UNITED STATES PATENT AND TRADEMARK OFFICE

APPLICATION NO.	FILING DATE	FIRST NAMED INVENTOR	ATTORNEY DOCKET NO.	CONFIRMATION NO.
10/674,704	09/30/2003	Tony A. Opheim	42.P16903	4545

Office Action Summary	Application No. 10/674,704	Applicant(s) OPHEIM, TONY A.	
	Examiner Leonardo Andújar	Art Unit 2826

DETAILED ACTION

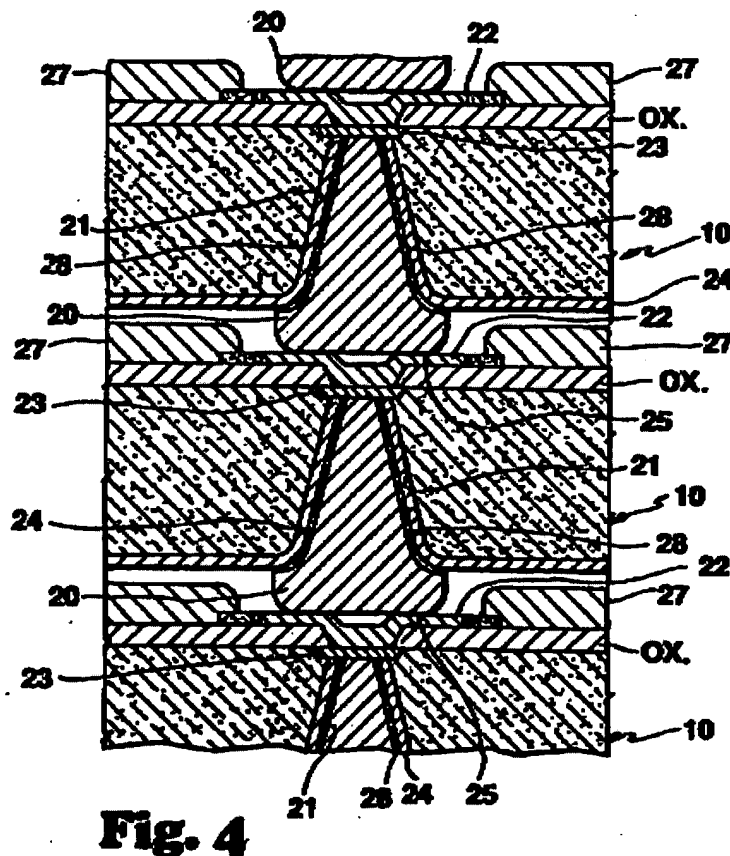
3. Claims 1, 3-7, 20, 22-24 and 27 are rejected under 35 U.S.C. 102(b) as being anticipated by Gnadinger (US 5,229,647).
4. Regarding claim 1, Gnadinger (e.g. figs. 4 and 6) shows an apparatus, comprising: a first end of a via 21 disposed in a semiconductor support layer 10, the first end (bottom end) having a first diameter; and a second end of the via having a second diameter (top end), the first diameter greater than the second diameter.

5. Regarding claim 3, Gnadinger shows that the first end forms a semi-cone in the semiconductor support layer.
6. Regarding claim 4, Gnadinger shows that a dielectric layer 24 disposed proximate to the semiconductor support layer, the via to pass through the dielectric layer (e.g. fig. 6).
7. Regarding claim 5, Gnadinger shows that a diameter of the via in the dielectric layer is similar to the first diameter.
8. Regarding claim 6, Gnadinger shows a contact 43 disposed on the dielectric layer and electrically coupled to the via.

10. Regarding claim 20, Gnadinger (e.g. figs. 4 and 6) shows a die package, comprising: a semiconductor support layer 10 including a via 21 having a first end (bottom end) and a second end (top end) in the semiconductor support layer, wherein a diameter of the first end is greater than a diameter of the second end; a dielectric layer 24 disposed proximate to the semiconductor support layer wherein the via passes through the dielectric layer; and a contact disposed 43 on the dielectric layer, the via coupled to the contact.

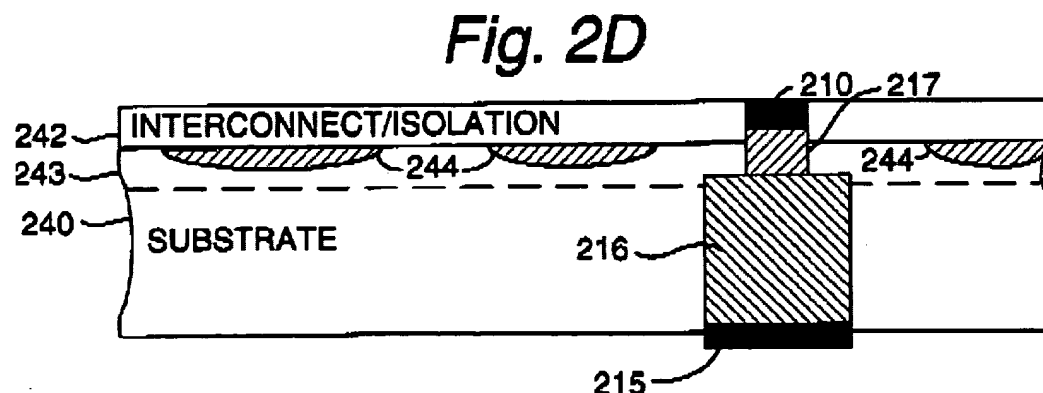
14. Regarding claim 27, Gnadinger the first diameter is approximately twice the second diameter.

17. Regarding claims 2, 21 and 25, Gnadinger shows most aspects of the instant invention except for a shaft between the first end and the second end wherein the shaft has a diameter similar to the second diameter. Nevertheless, Hsuan (e.g. fig. 4D) a via including a shaft between a first end 216 and the second end 217 wherein the shaft has a diameter similar to the second diameter.
